# SAN FRANCISCO PLANNING DEPARTMENT

## Discretionary Review Full Analysis

*Date:* August 31, 2011  
*Case No.:* 2010.0479DD  
*Project Address:* 1456 Chestnut Street  
*Permit Application:* 2010.06.16.4608  
*Zoning:* RH-3 (Residential House, Three-Family)  
40-X Height and Bulk District  
*Block/Lot:* 0480/003E  
*Project Sponsor:* John Schlesinger, A.I.A.  
351 Valley Street  
San Francisco, CA 94131  
*Staff Contact:* Aaron Starr – (415) 558-6362  
[Aaron.Starr@sfgov.org](mailto:Aaron.Starr@sfgov.org)  
*Recommendation:* **Take DR and Approve the Project with Modifications**

① SOUTH ELEVATION

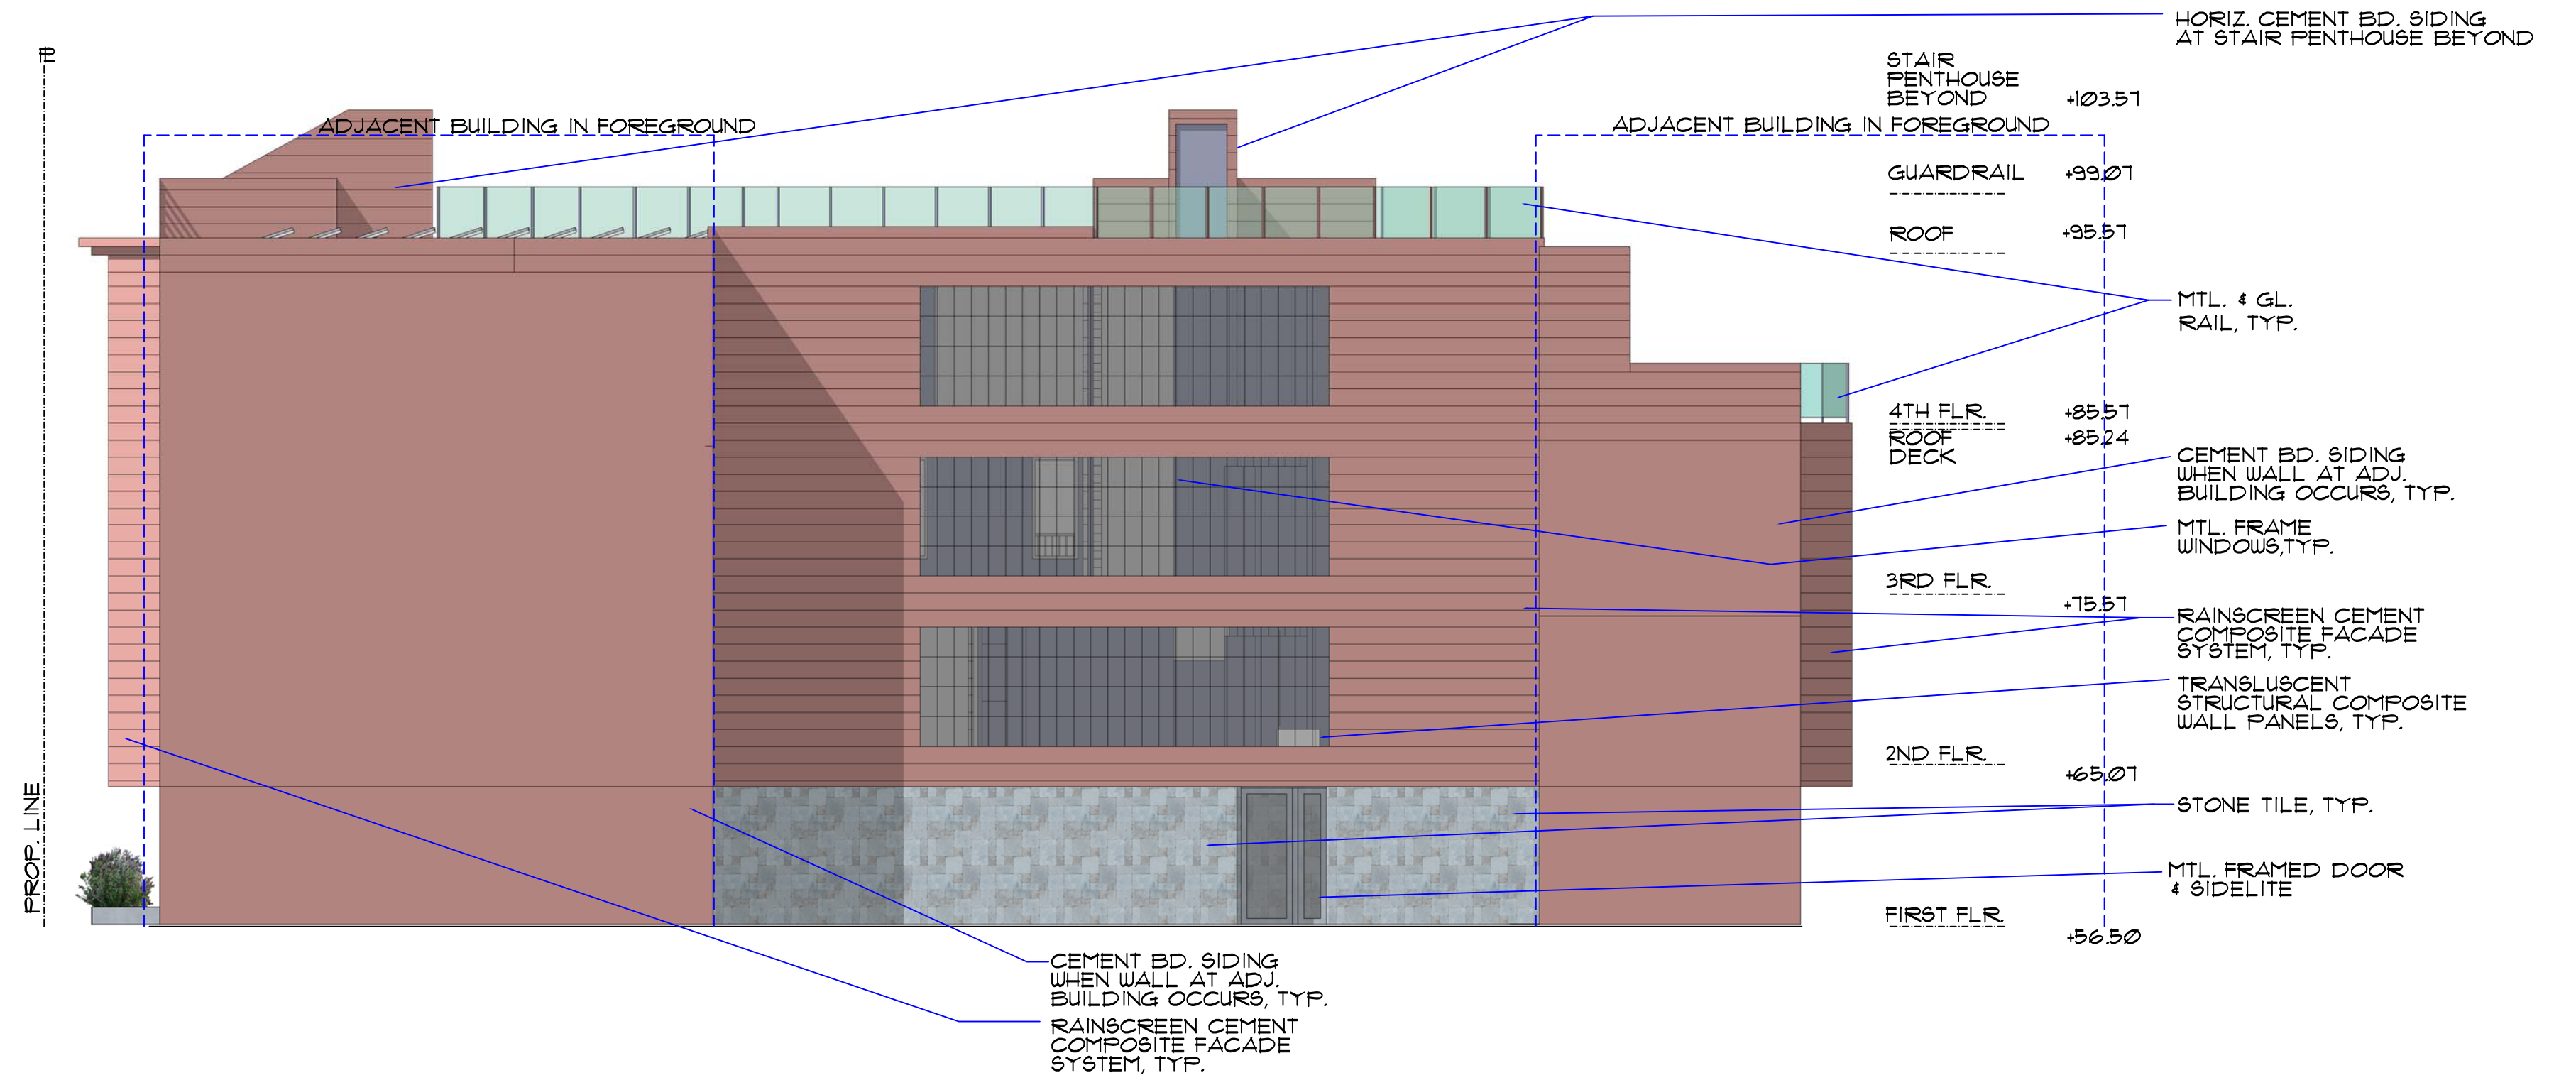
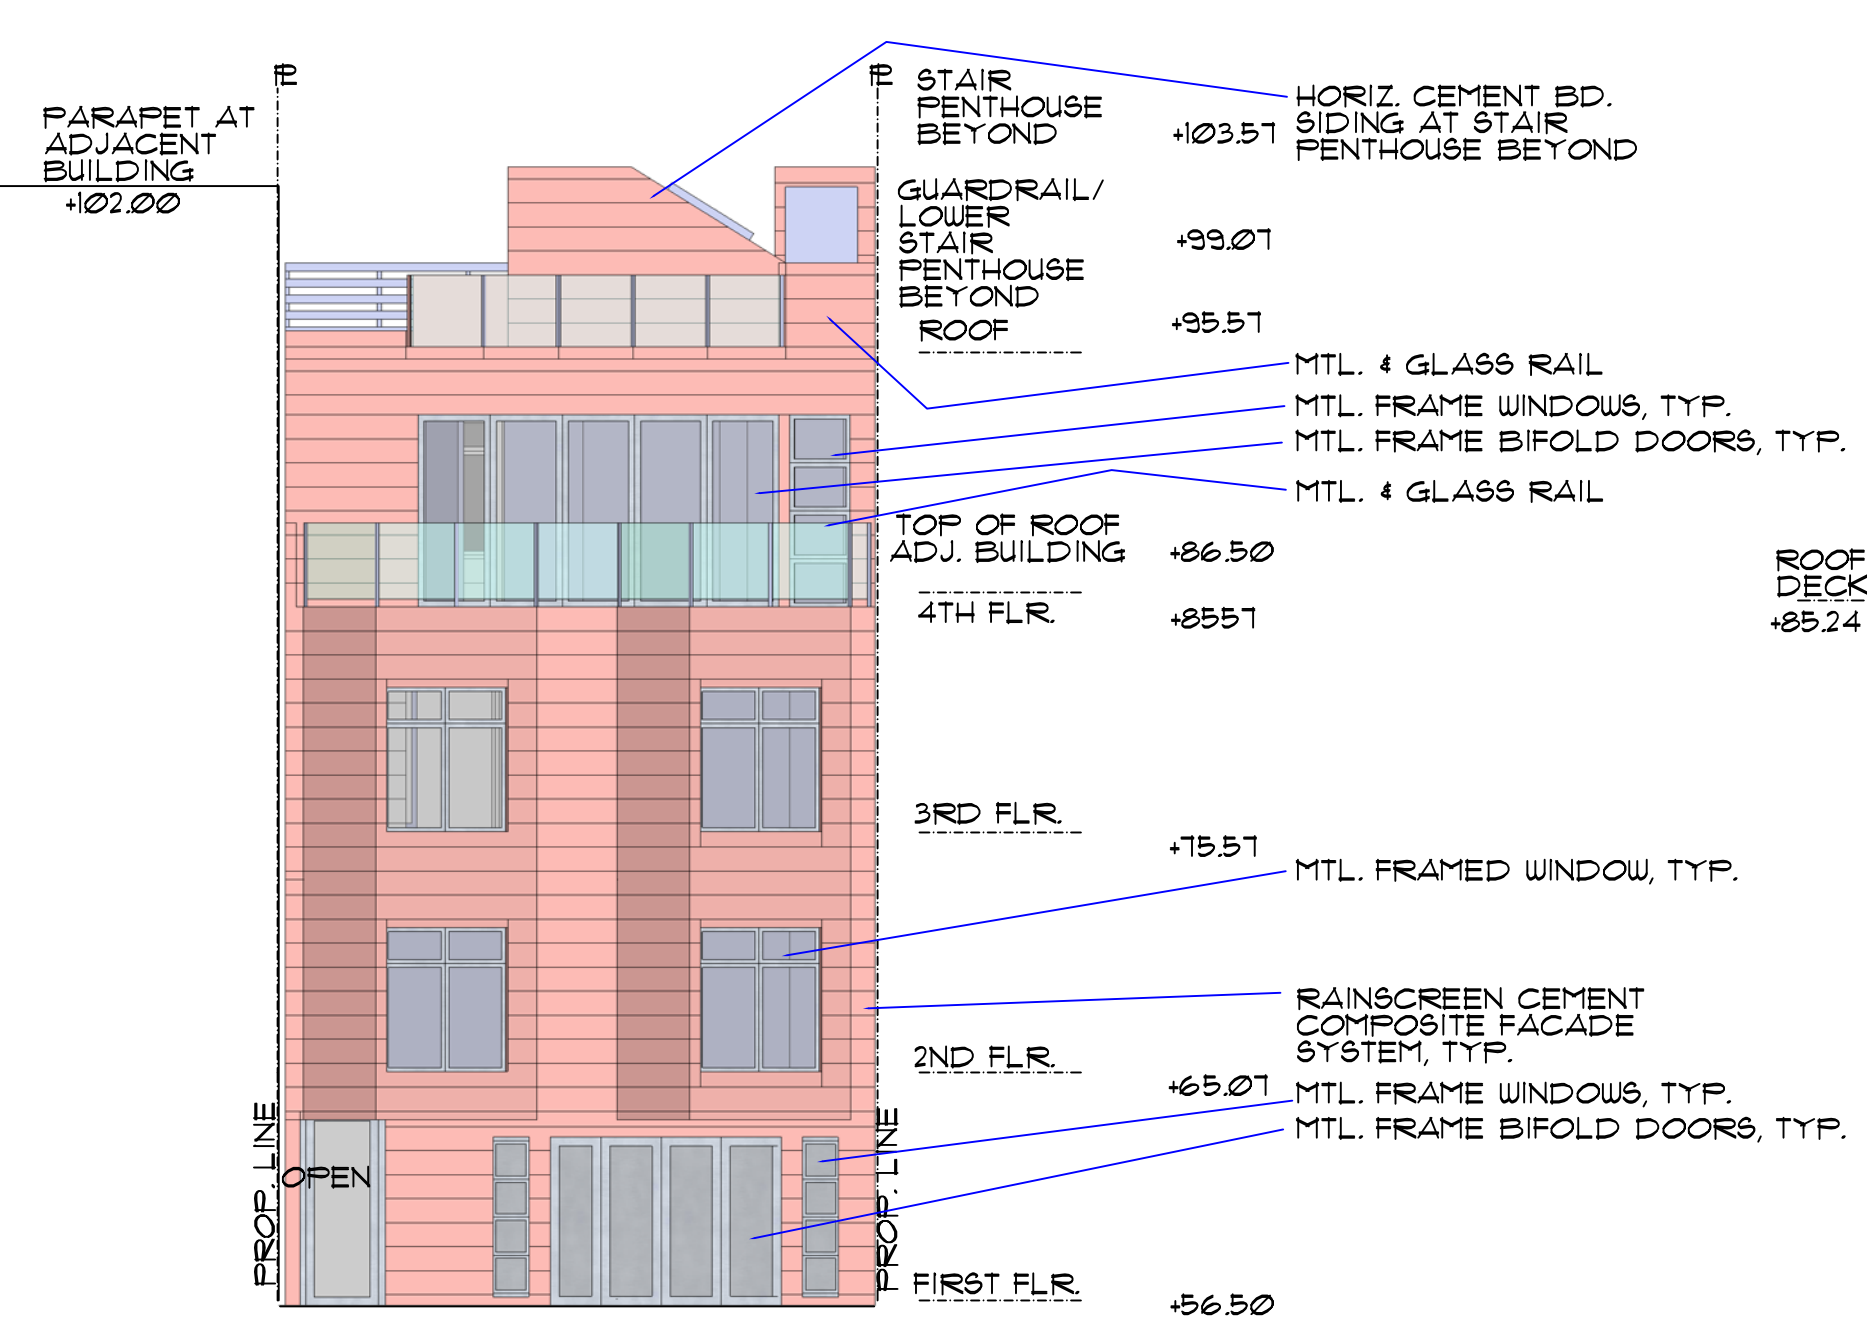
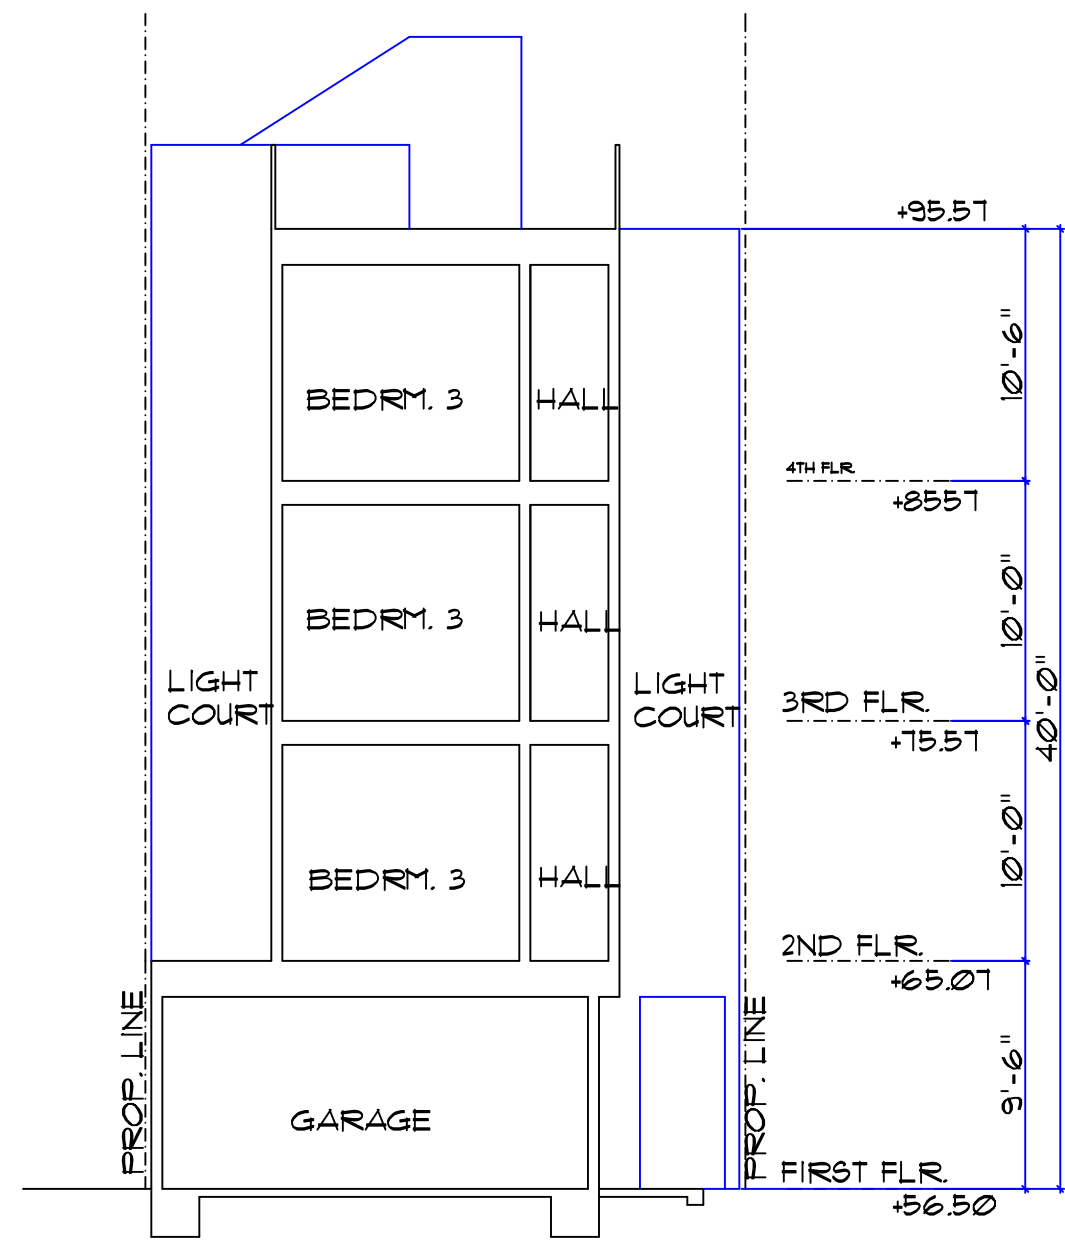
The RDT also has some concerns about the front façade, which have been shared with the project sponsor. The Department asks that the project sponsor eliminate the proposed parapet and instead use a lower solid cornice to cap the building and to act as a transition between the two adjacent structures. The RDT suggests that the style of the bay windows be unified, and that the entry and windows on the left side of the façade be more balanced rather than stacked against the side property line.

**Comments:** The Department does not find that the proposed façade is compatible with or complementary to the blockface and required changes to the front façade. In addition to requiring revisions to the fenestration pattern, the Department also sought revisions to the parapet so that it would provide a better transition between the taller building to the east and the shorter building to the west.

**Comments:** The Department does not find that the proposed bay windows are complementary to the blockface nor do they help create a successful design. The stair penthouse is placed in a very visible area of the building and the parapet could do a better job of transitioning the taller building to the east to the shorter building to the west.

**Comments:** The proposed windows on the left side of the building’s front facade are awkwardly placed and do not add to the building’s overall architectural character.
